Hip Bone Creek Baseline Monitoring Report

Hip Bone Creek Restoration Site
Cape Fear River Basin - 03030003
Monitoring Year 00
DMS Contract 7528
DMS Project Number 100059

MEMORANDUM

Subject: Hip Bone Creek Mitigation Site
MY-00 Baseline Monitoring Report Comments
Cape Fear River Basin CU 03030003
NCDMS Project # 100059
Contract # 7528

**CURRENT CONDITIONS PLANVIEW PAGE
HIP BONE CREEK RESTORATION SITE
CHATHAM COUNTY, NC**

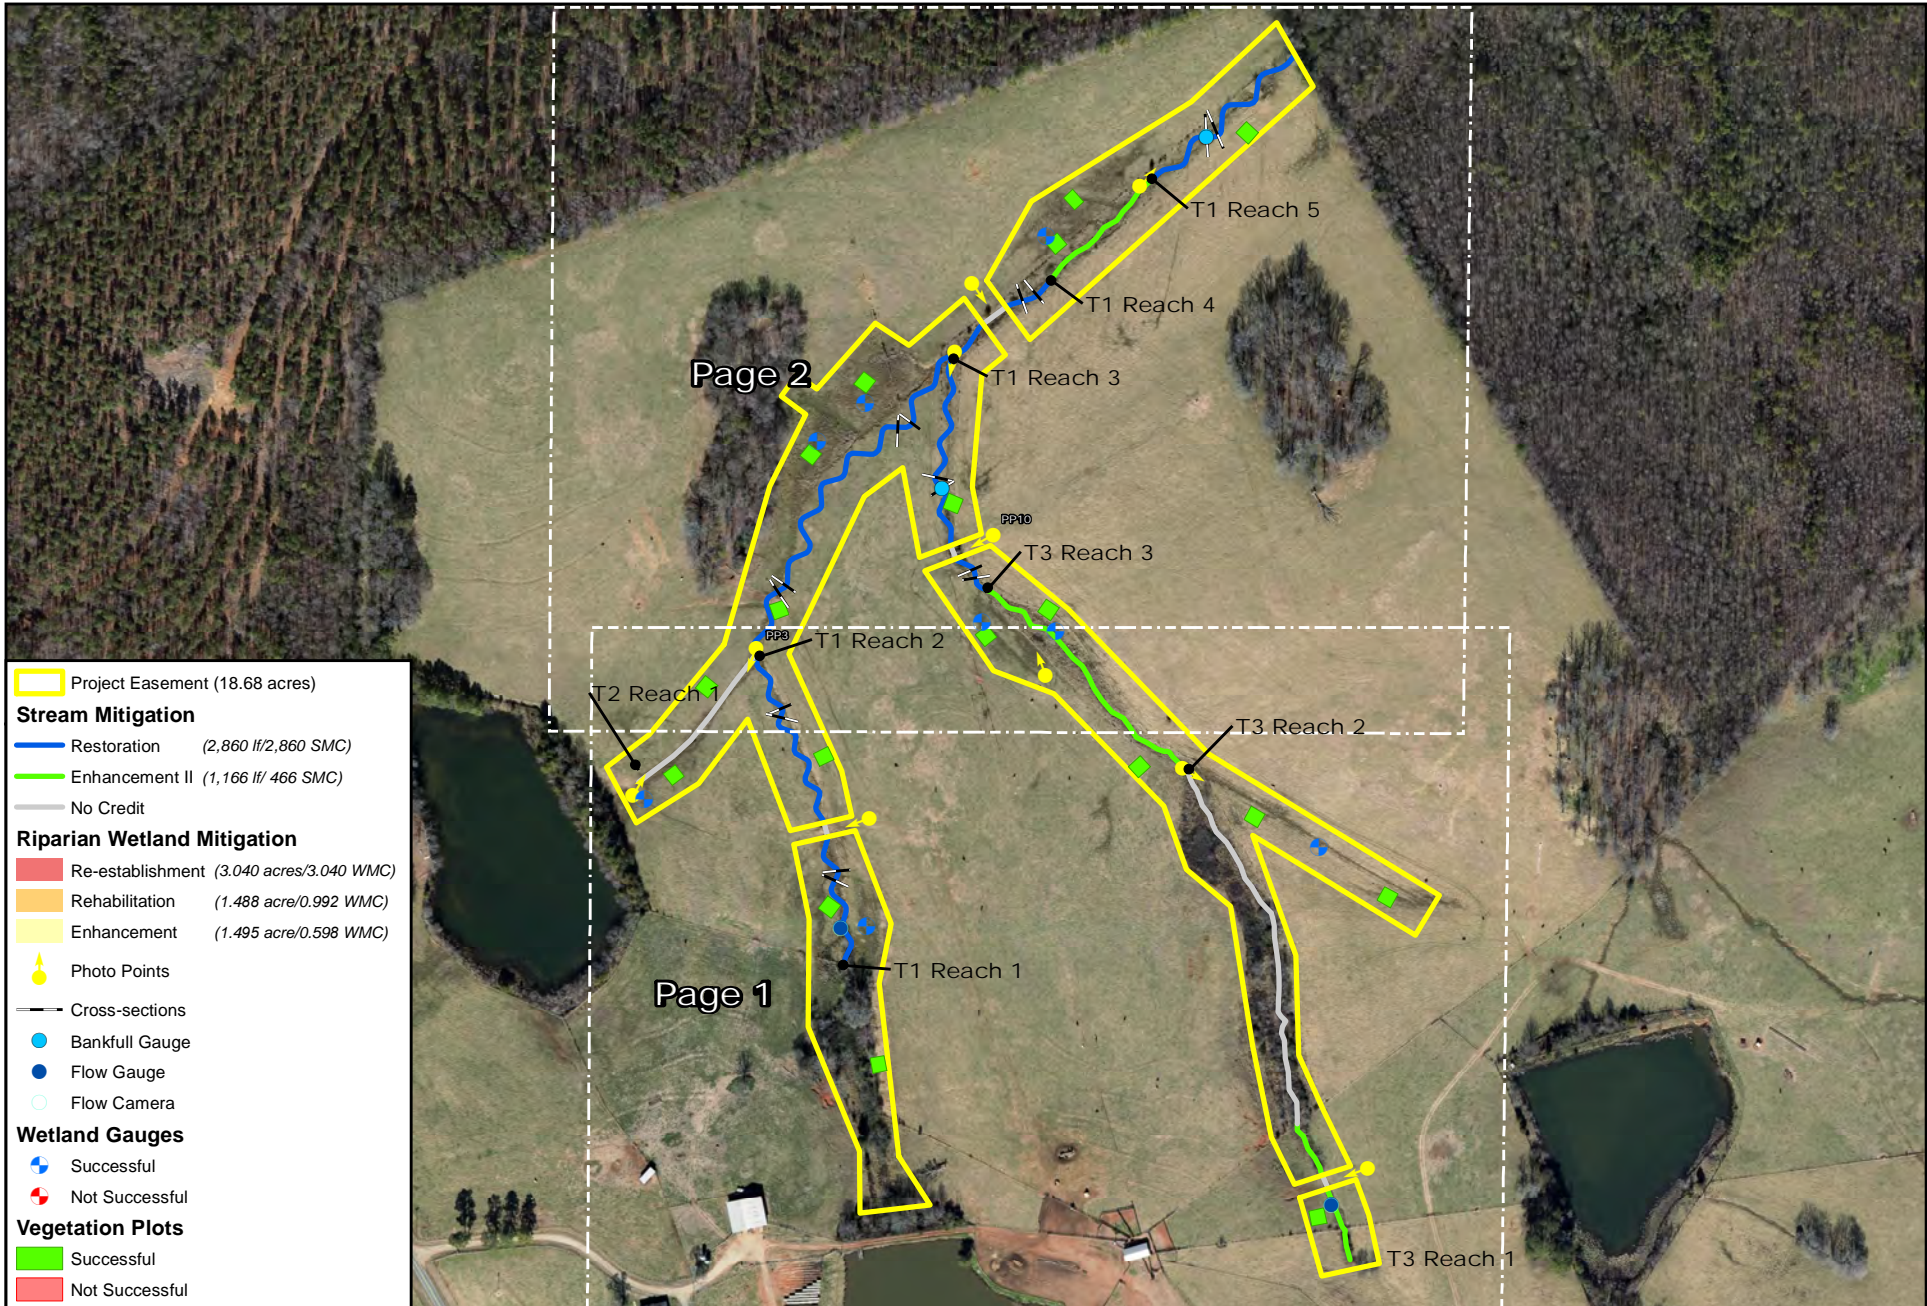
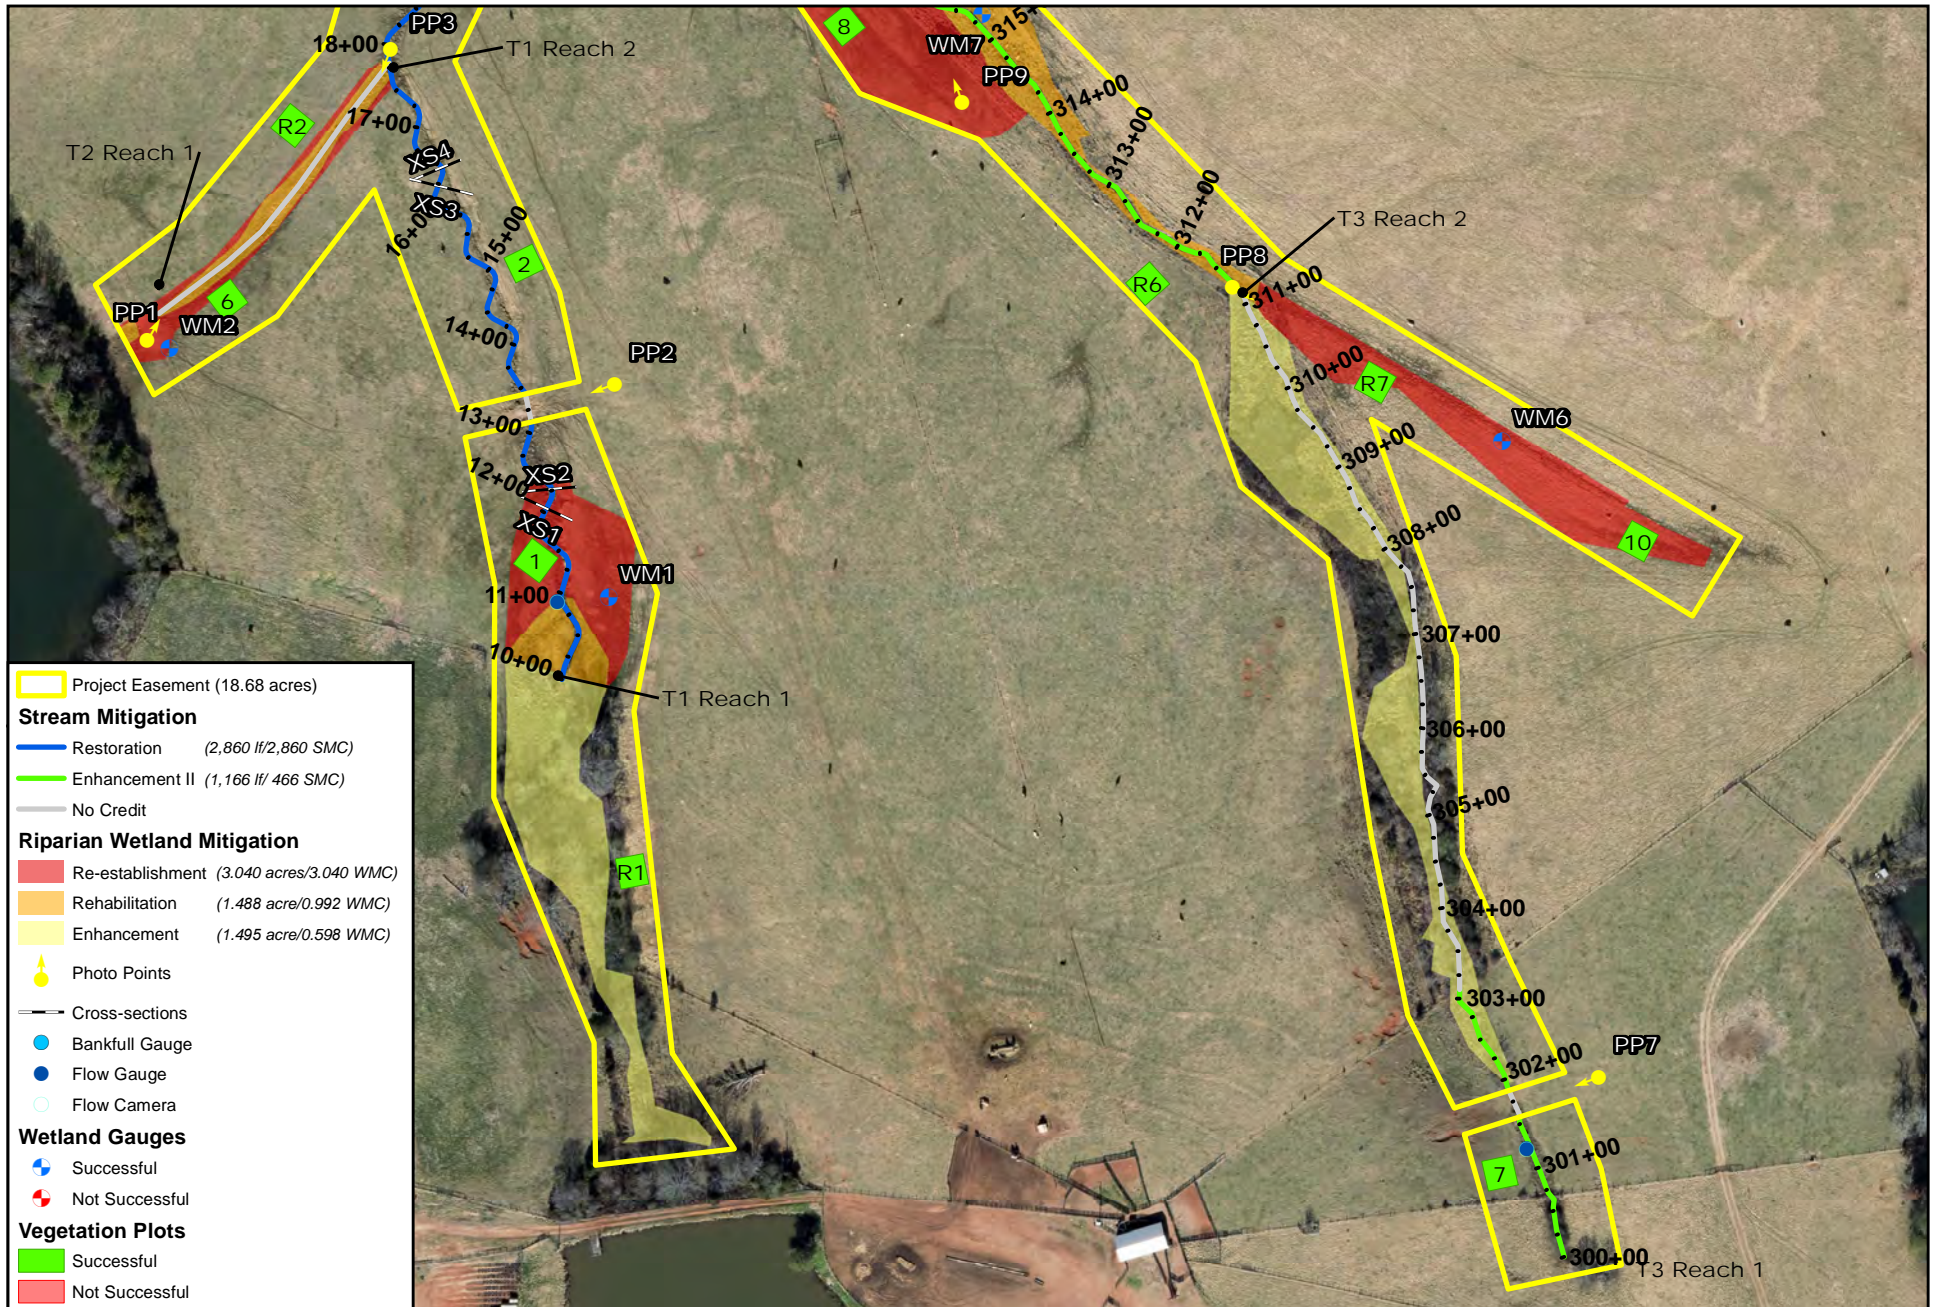
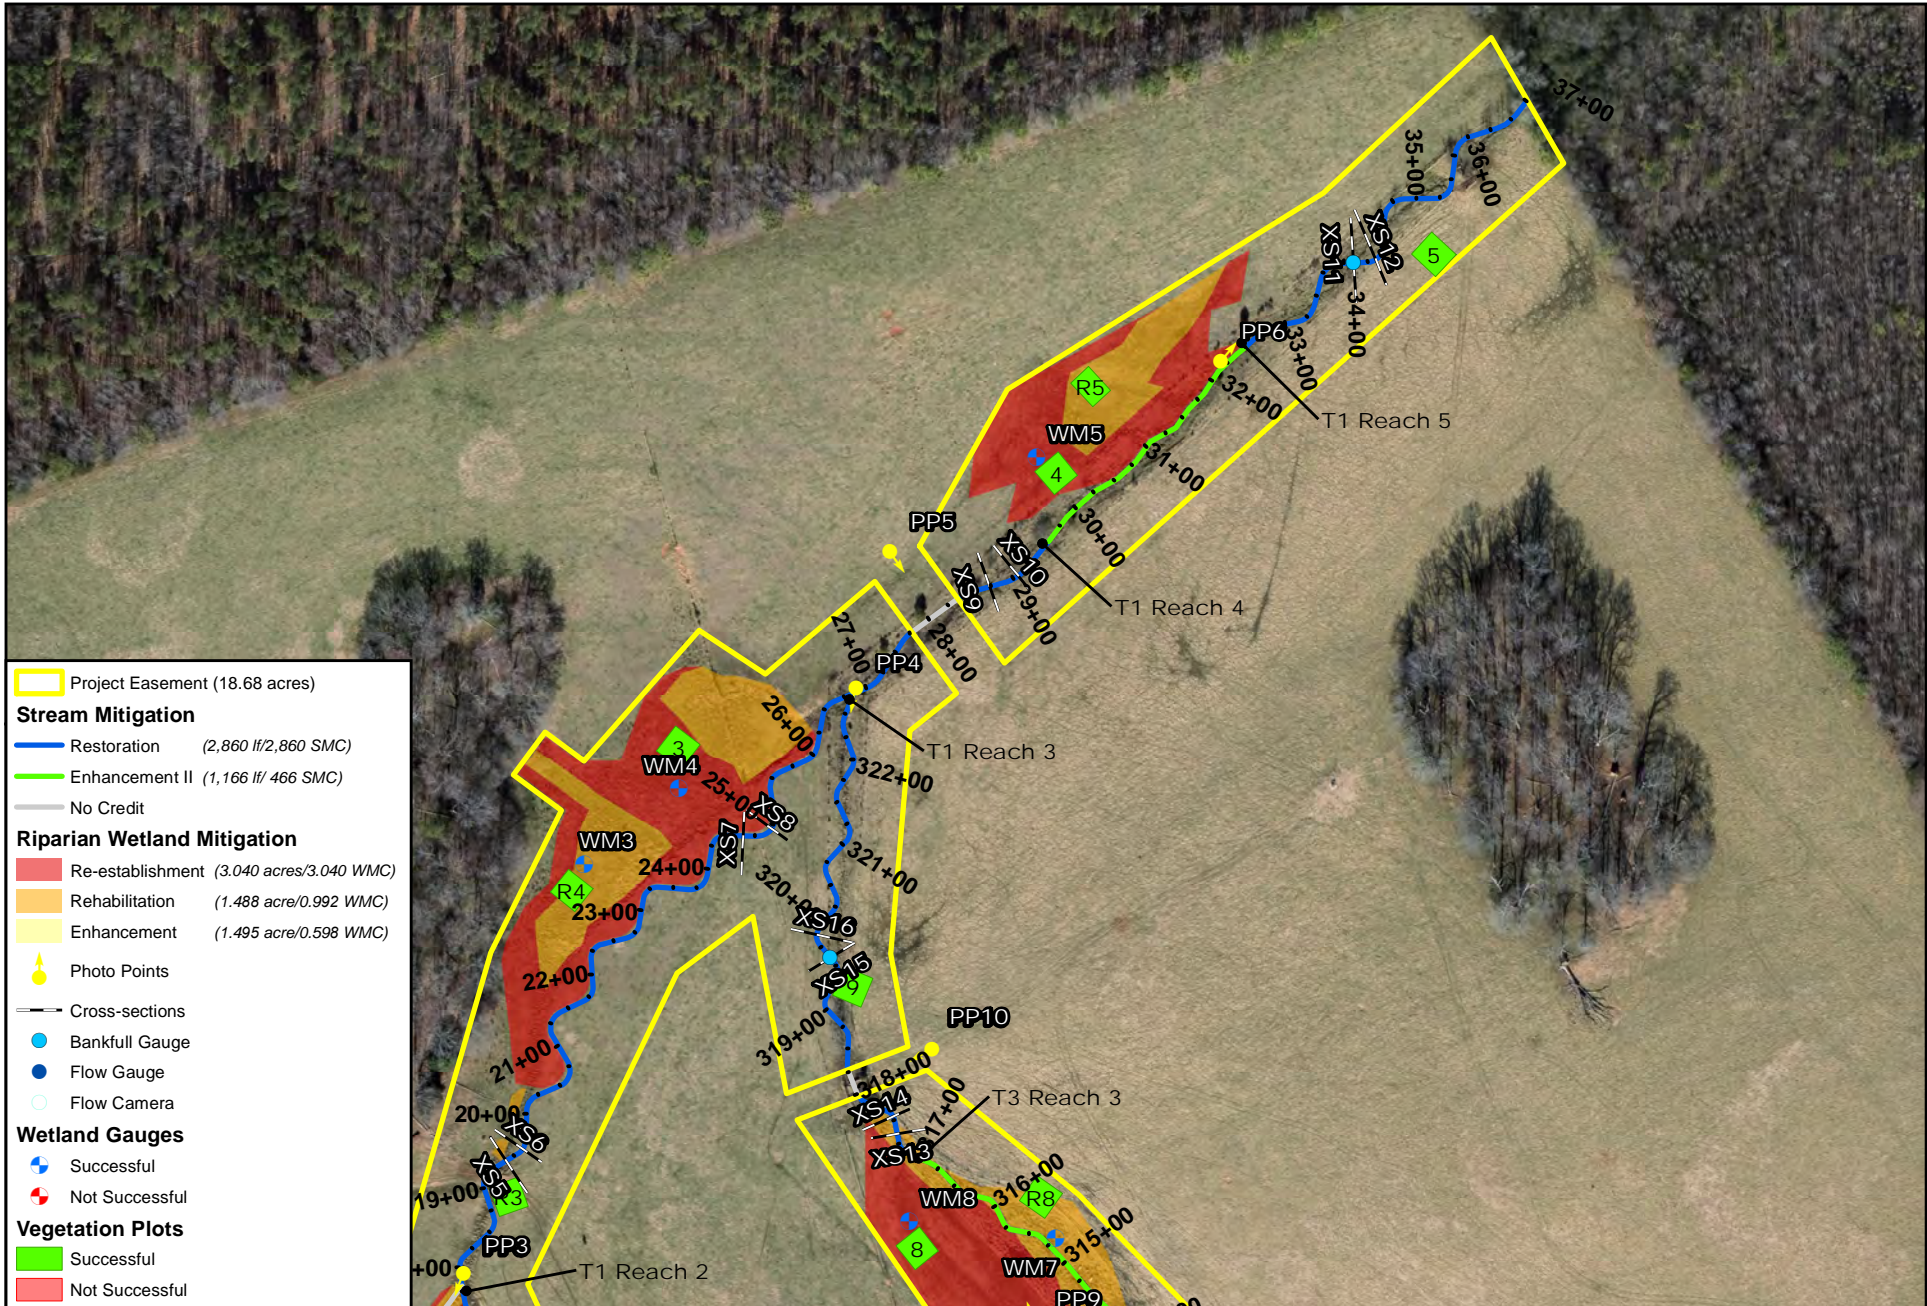
- CCPV – The photo points should be labeled so they can be matched with the photo log.
KCI Response: The missing labels have been added to the CCPV.

AS-BUILT PLANS

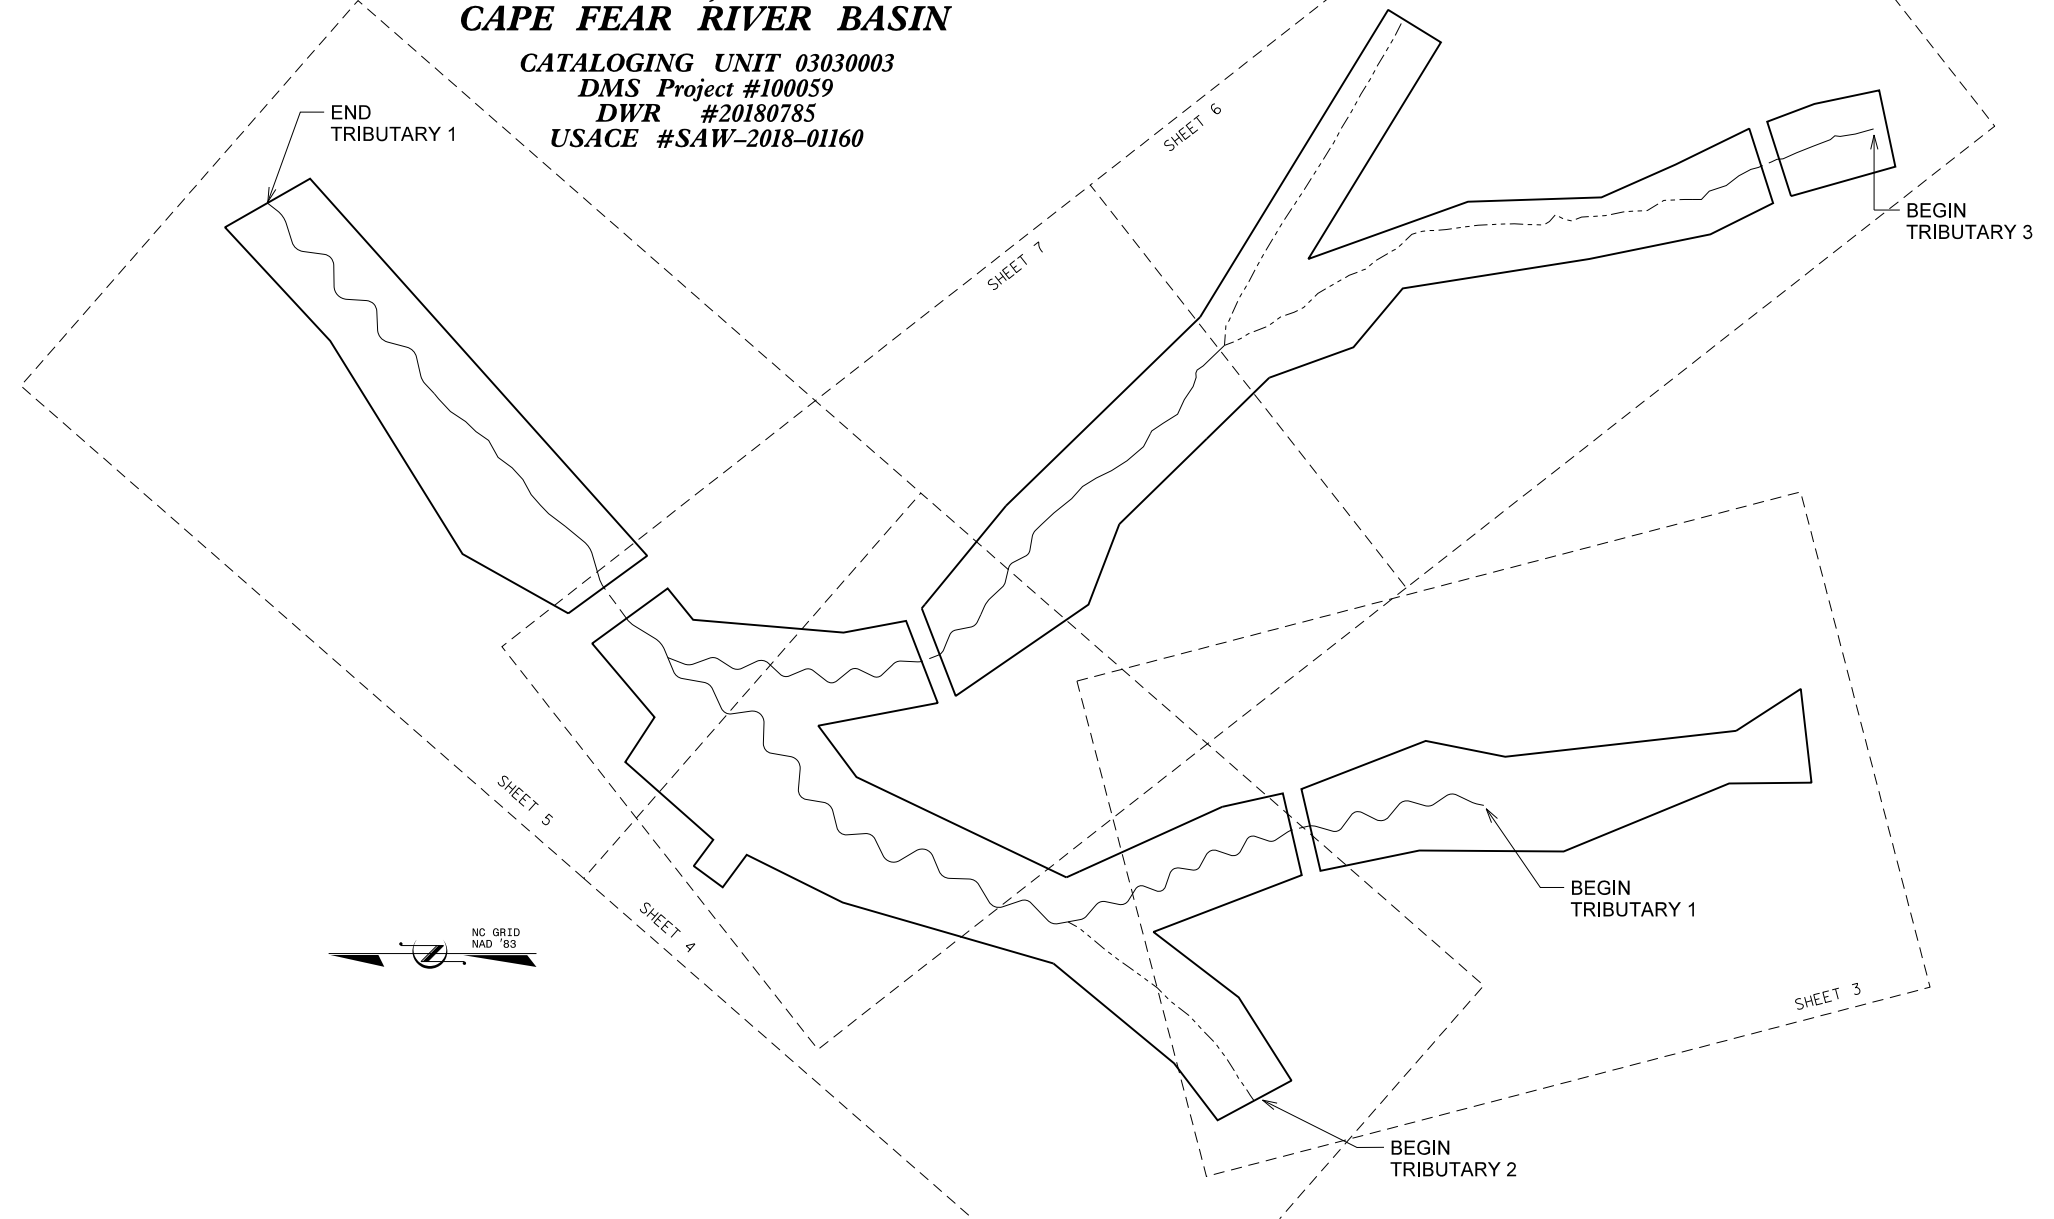
- Record Drawing / As-built Sheets
 - The Title Sheet should include the DMS Project Number (100059), DWR # (20180785), and USACE #(SAW-2017-0016160). The asset table should be updated based on the response to Comment 3 above.
KCI Response: These changes have been made.
